#### PLANNING COMMISSION WORKSHOP AGENDA

Wednesday, December 20, 2023 | 3:00 p.m.
Planning & Building Dept. Conference Room – 196 Laurel Street

**PIN: 368-07-01-0101** (**Lot 90, Rollingson Subdivision**) – The applicant, Jamie Steele, Diamond Shores. is requesting a design modification to allow for the issuance of a building permit on an existing lot of record that lacks frontage onto a publicly maintained street.

*Previously Deferred* ...Proposed Development Agreement by Lennar Carolinas, LLC and Thomas & Hutton, for proposed development of property located on Hwy 378, Juniper Bay Rd, and Dunn Shortcut Rd, to be known as the Tributary Planned Development, and consisting of approx. 486 +/- acres (PIN's 336-00-00-0043, -0044, -0045, 336-13-04-0006, 336-14-04-0011, 336-15-03-0003, 370-00-00-0011, 370-04-01-0004, 337-00-00-0009, -0011, -0012, and 337-08-01-0004).

Tributary PD shall be the subject of master covenants, conditions and restrictions (CCR's), which will apply to the community as a whole, as well as additional CCR's which may be applicable only to certain portions of the community.

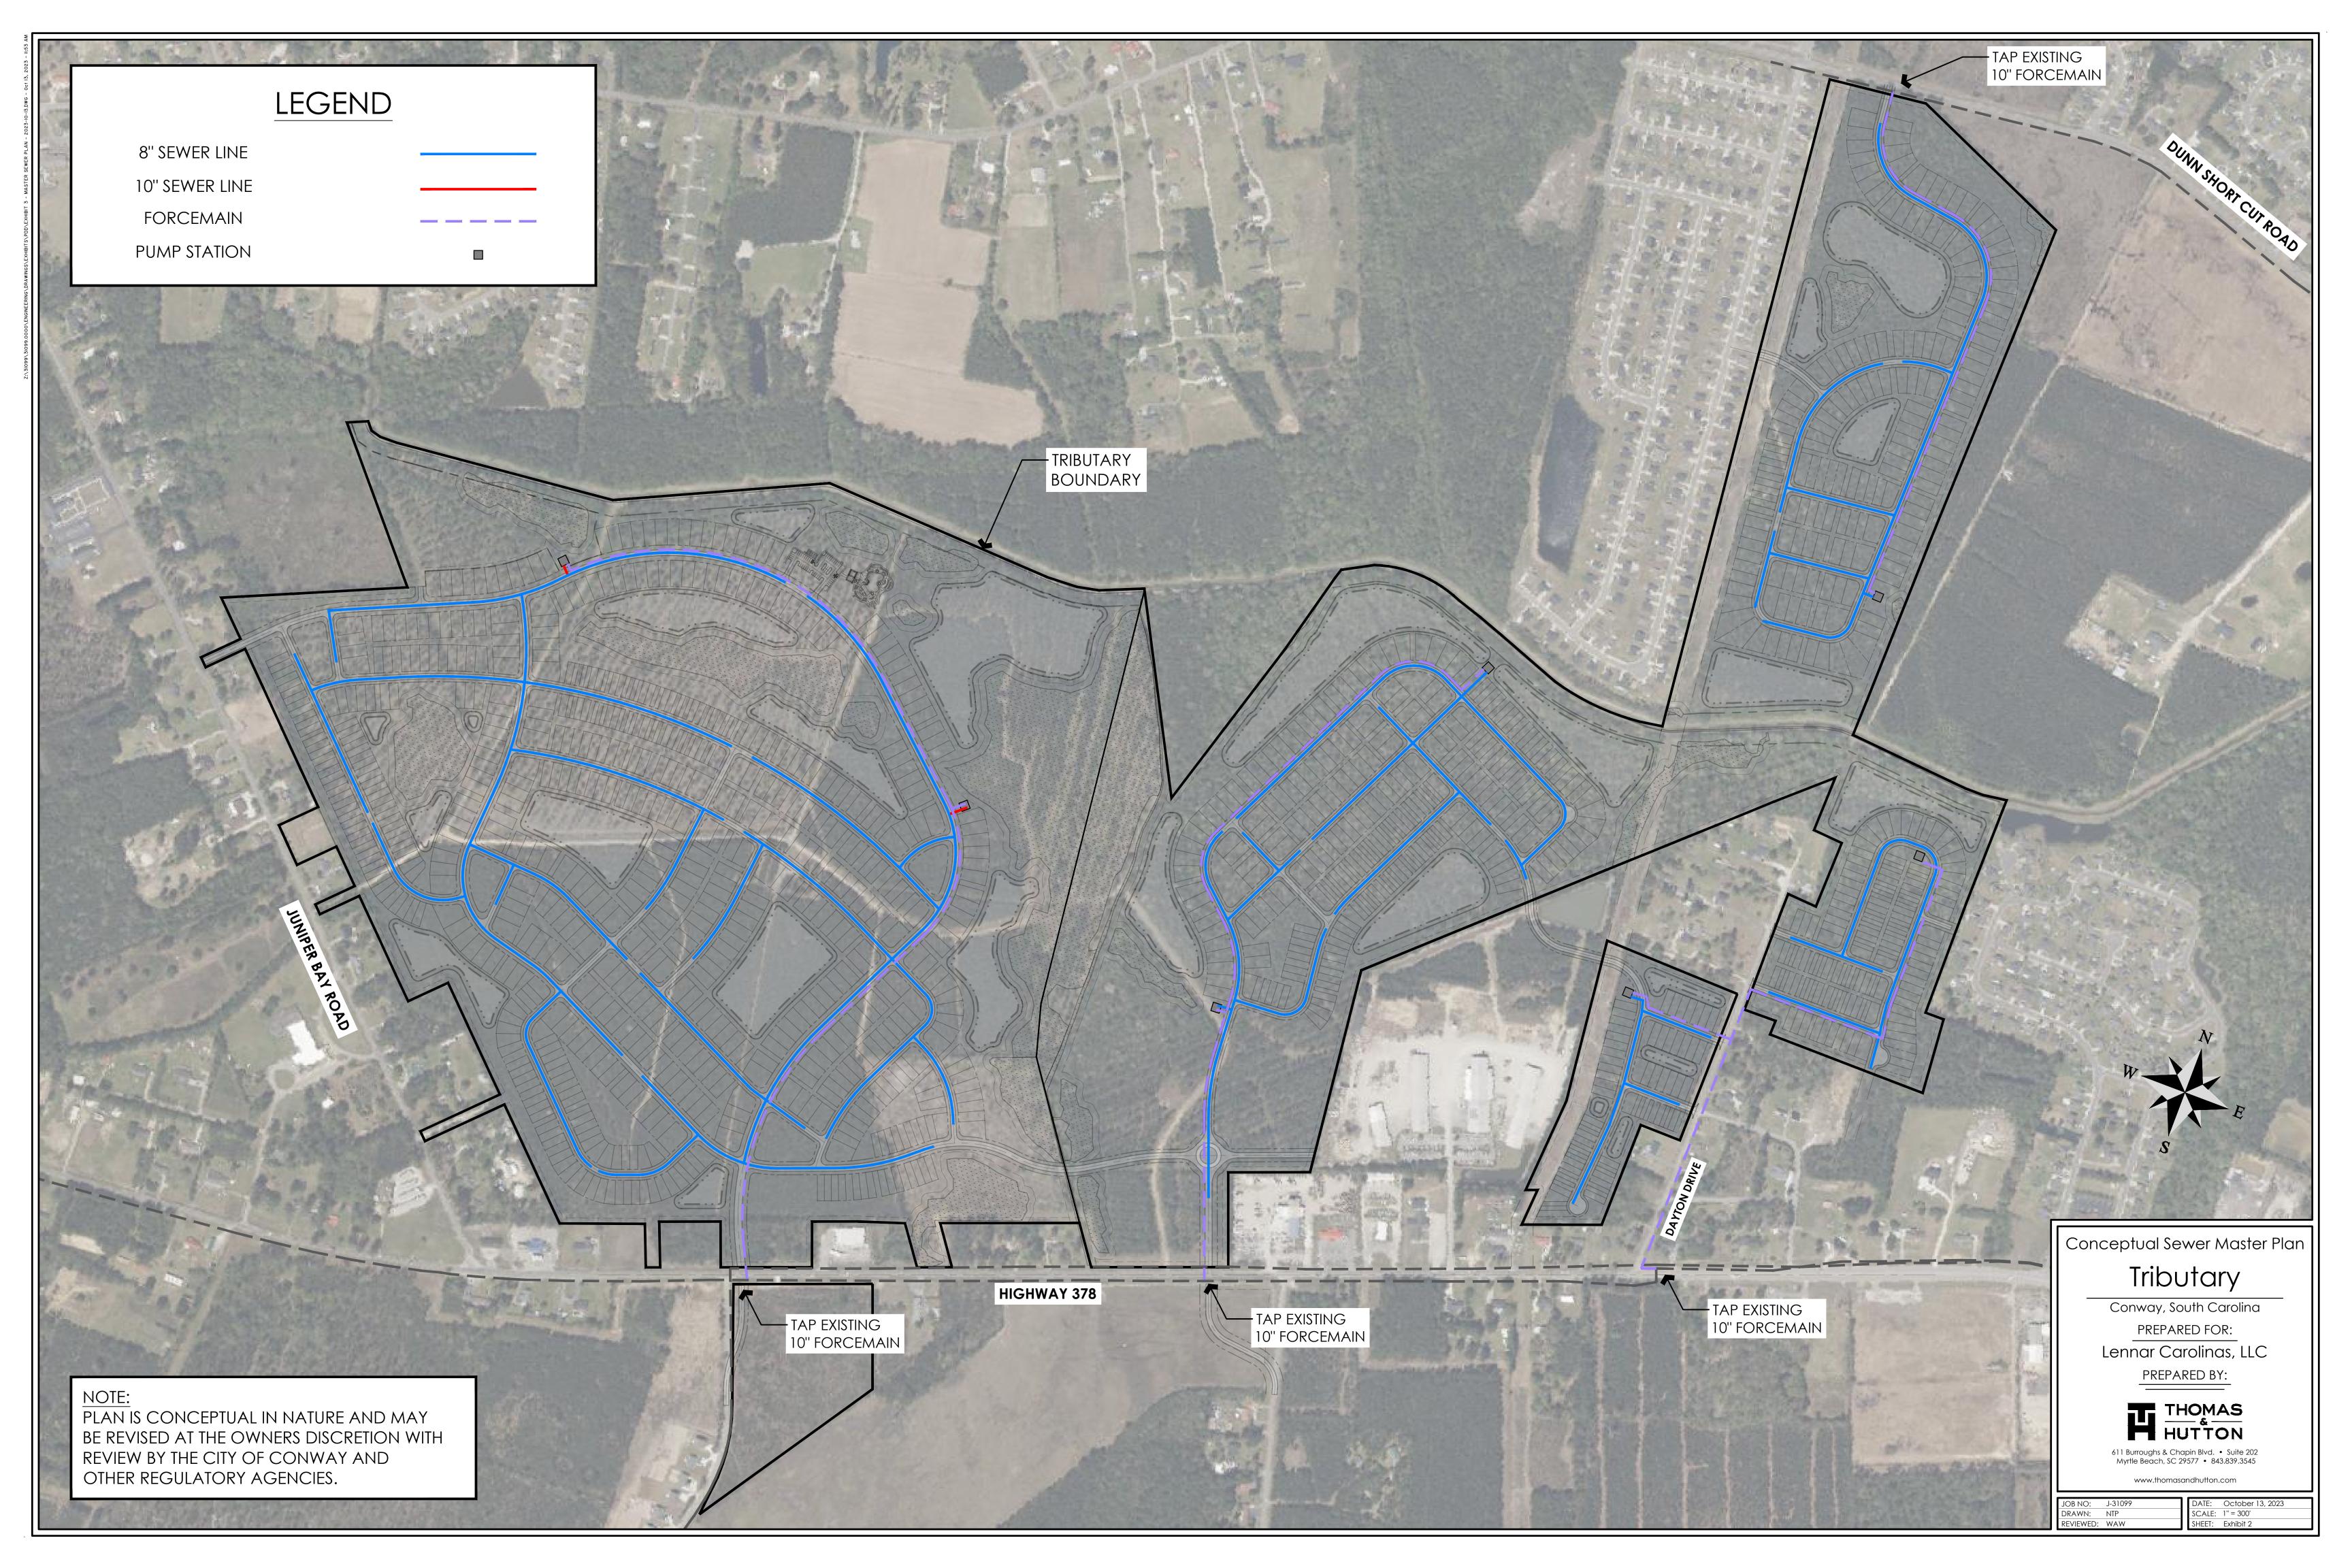
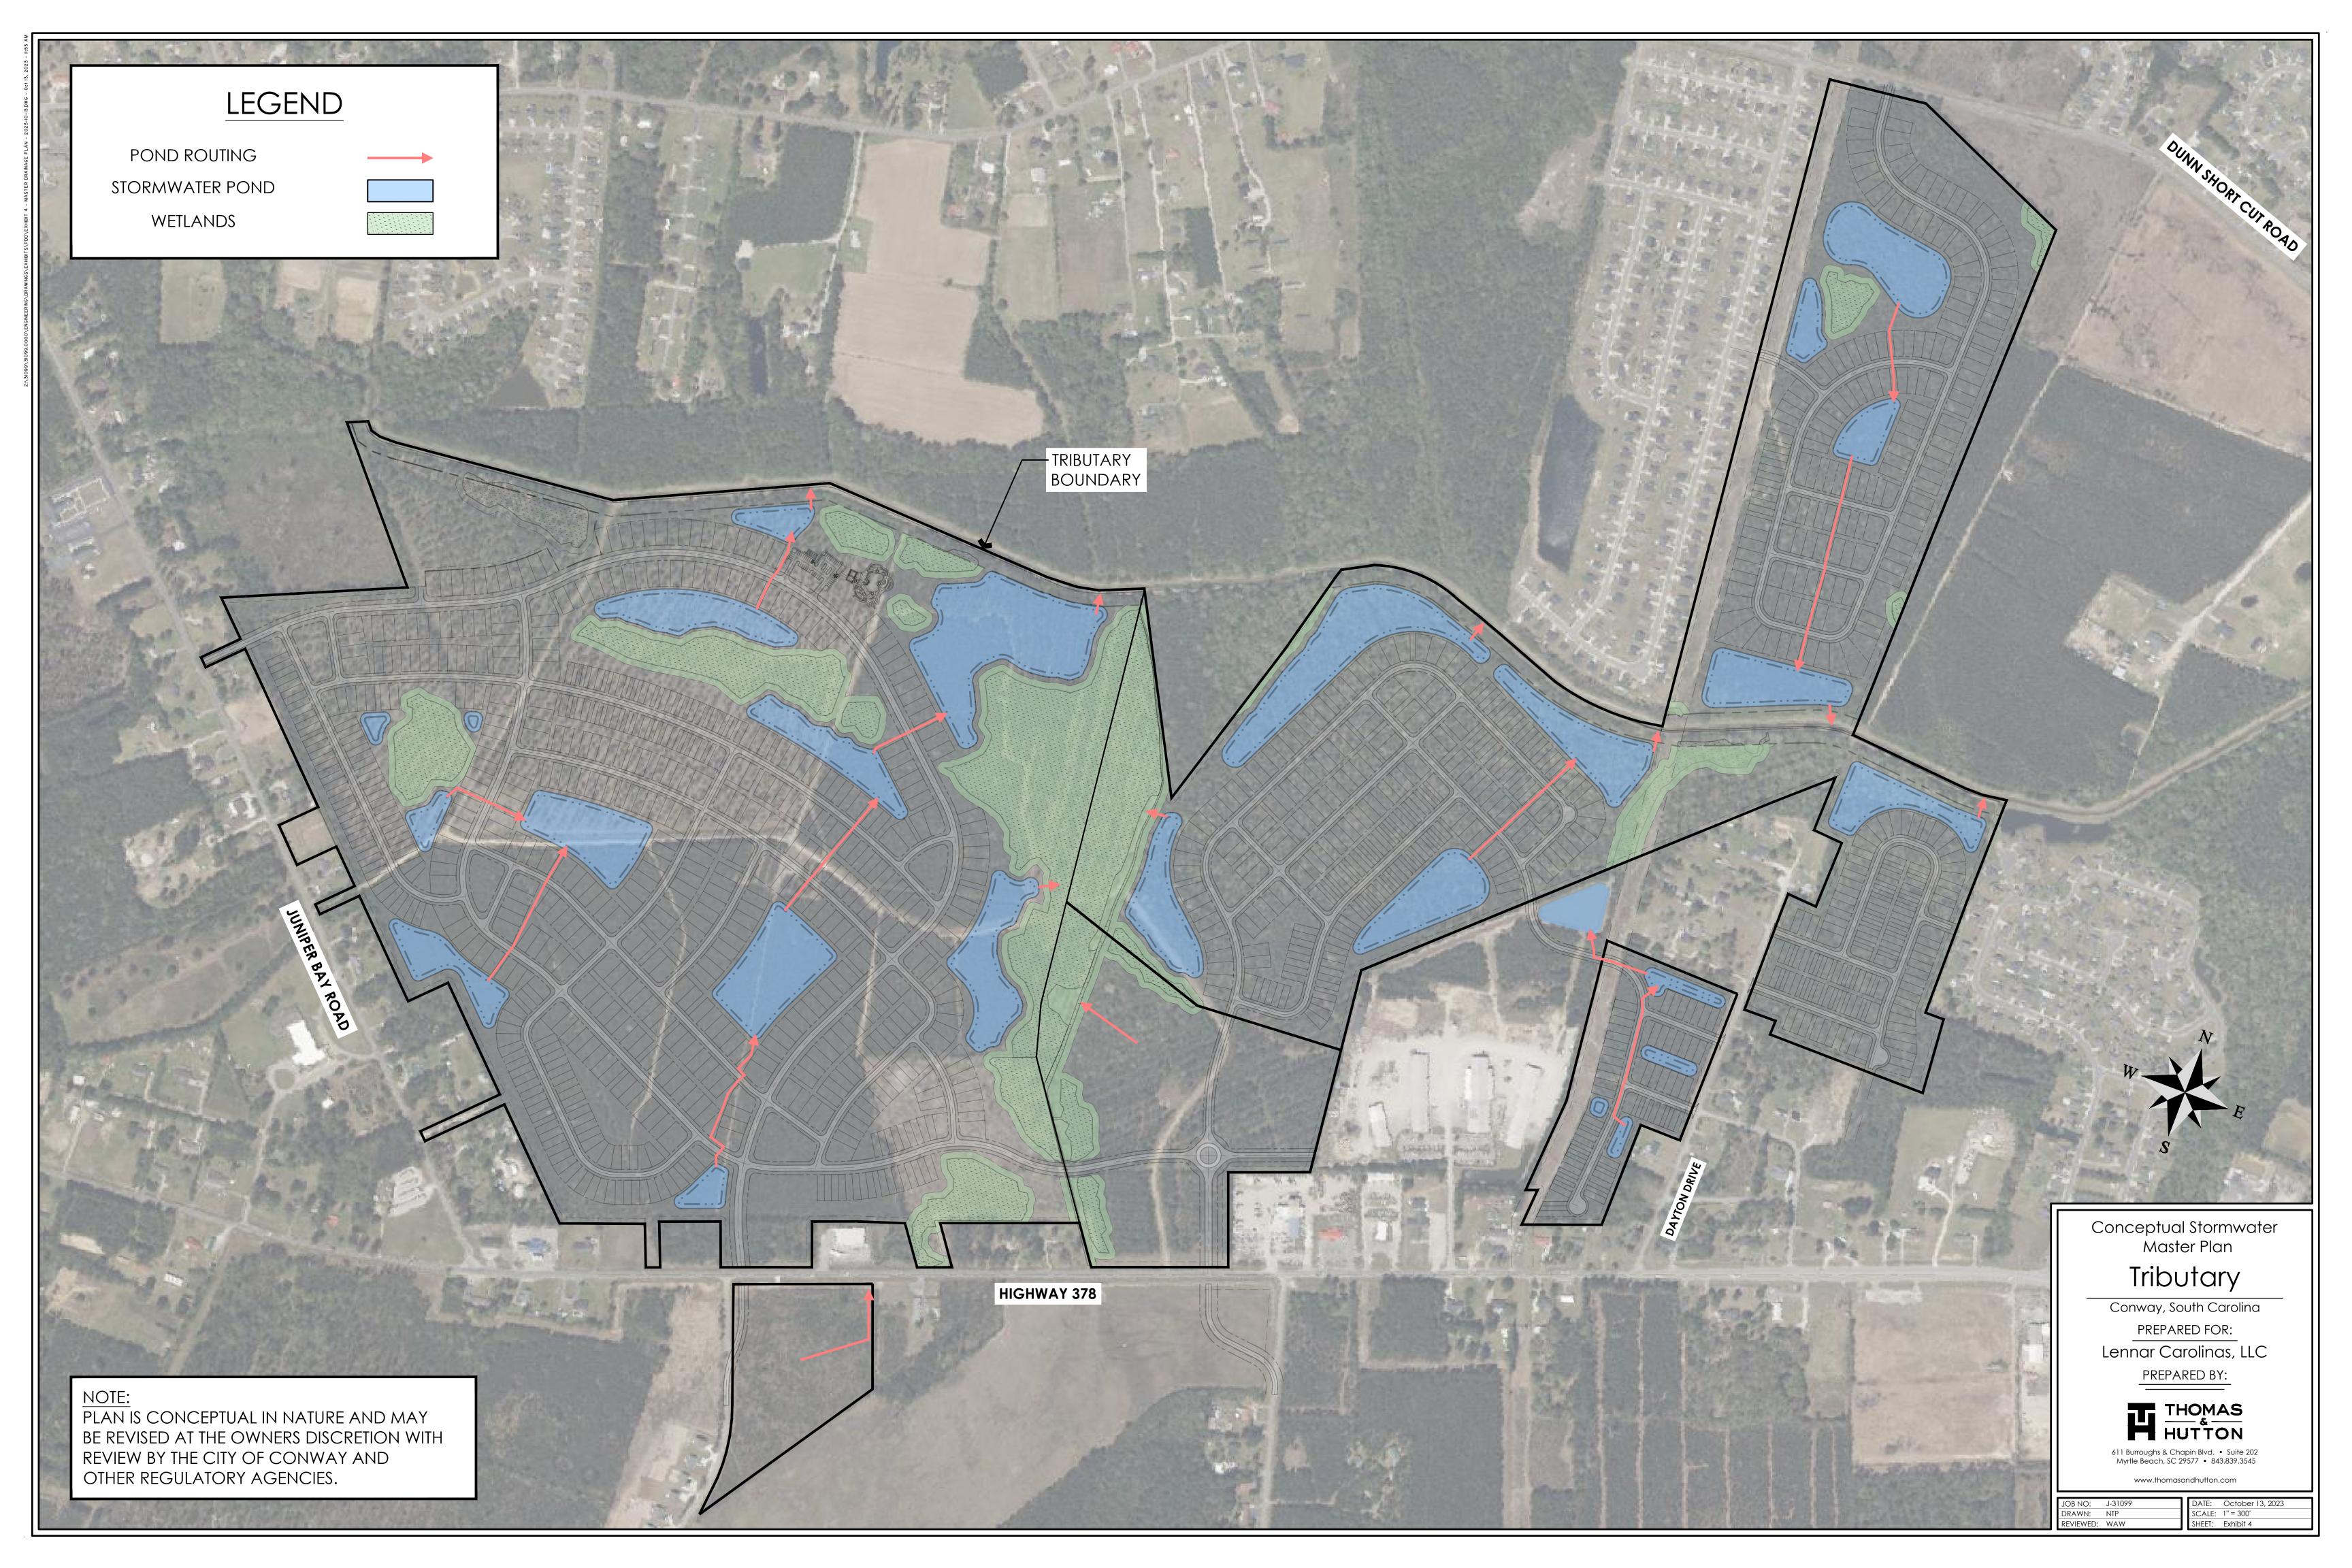
PD NARRATIVE COMMENTS			
PD Narrative Section	Issue	Additional Info / staff Comments	
Section 1: Purpose and Intent Statement	(pg. 4) Reference to nearby regional roadways: includes Highway 701 S, but not Highway 378. Is this intentional?		
Section 2: Development Summary	(pg. 4) 1 <sup>st</sup> paragraph: Remove reference to Sec. 6.4.2 of the UDO.	Just specify "in accordance with the City of Conway UDO"	
	(pg. 4) 3 <sup>rd</sup> paragraph: "transfer of units between districts"	should this be tracts or phases instead?	
	(pg. 4) 3 <sup>rd</sup> paragraph: transfer of units between tracts	The flex tracts proposing multifamily should not be included in the transfer of densities between like tracts. This should be restricted between the "R" tracts.	
	(pg. 4) 3 <sup>rd</sup> paragraph: "use districts shall be capped at 125% pf the density shown in the development summary table"	Staff would prefer that the wording be revised to state something similar to "density may be shifted between tracts with like uses, provided that the <b>overall</b> density across the entire PD/across all tracts is not increased"

(pg. 5) Use District column: Flex District F-1 and Flex District F-2.	Type column: only multifamily or townhome is listed. Shouldn't this include commercial as well?	
Development Summary Table	(pg. 5) Use District column: Commercial C-1 and Commercial C-2	Type column: shouldn't Light Industrial (LI) be added also?	
Section 3: Permitted Uses and Dimensional Requirements			
Dimensional Standards		Staff comment: Lot widths are very dense for this area (20' to 52' lot width, which vary throughout the project area)	
Section 4: Additional Requirements	(pg. 8) 7.A.: remove reference to Section 10.3.9	remove "Section 10.3.9" from sentence.

throughout the PD	(pg. 9)		Will the buffer be
District	8. Landscape Buffers and	PD External Perimeter Buffer	increased to 50' where
District	Quantities		adjacent to existing,
	Quantities		adjacent residential
			properties, as previously
			discussed?
			aiscussea?
			Remove reference to
		Footnotes 1 and 2	specific section of UDO

(6.5.2)
Section 5: Design	1. Landscape buffers between		
Standards and	commercial uses shall not be	Which tracts will these be applical	hle to?
Modifications	required.	Willest tracts will these be applical	ole to:

(p. 10)			
(β. 10)	2. Where multi-purpose trails are parallel to and within		
	·	These locations should be illustrat	ed on an exhibit (i.e.
	required landscape buffers, the	street framework plan)	
	width shall be reduced to a Type		
	A buffer.

(p. 11)	timing of such conveyance,	case includes areas being conveyed to the City will include,	
	installation of improvements,	should be installed and usable by residents within a	
	dedication, etc., shall be	development.	
	negotiated between the	development.	
	developer and City Council.		
	TRAFFIC IMPROVEM	ENTS (ON SITE & OFF-SITE)	
ONSITE (w/ in	Local Road (see exhibit and the	50' right-of-way (ROW); however, each lane is only	
project area)	Street Framework Plan)	proposed to be 11' in width, making the pavement width a	
		total of 22', with 2' curb/gutter, 6' shoulder/planting strip,	
		an 8' multi-use path on one side of roadway, and 5'	
		concrete sidewalk on other side of road. The minimum	
		pavement width should be 24'.	
	Minor Collector Road (see	60' ROW with 24' pavement width (12' each side), 2'	
	exhibit and the Street	curb/gutter, 6' shoulder/planting strip on each side of road,	
	Framework Plan)	an 8' multi-use path on one side of roadway and 5' concrete

Flamework Flam	sidewalk on other side of road.	
	Callanta a Band		
	Collector Road	70' ROW with 28' wide pavement width, 2' curb/gutter, 8'	
		shoulder/planting strip on both sides, an 8' multi-use path	
		on one side and 5' sidewalk on the other side of the road.	
	Entrance Road (collector)	90' ROW with median (24' pavement width on one side of	
		median and 14' pavement width on other side of median),	
		2' curb/gutter, 8' shoulder/planting area on each side of	
		road, 8' multi-use path on one side of roadway and 5'	
		concrete sidewalk on other side of road.	
	Dayton Drive (variable width)	Dayton appears to be an approx. 50' ROW at the point in	
		which tracts R-3 and R-4 will be accessed; however, the	
		entrance to Dayton from Hwy 378 is smaller – approx. 30' in	
		width, and in order for the project to be compliant with	
		roadway standards of the UDO, the entire roadway (Dayton	
		Dr) must come into compliance. The applicant may have to
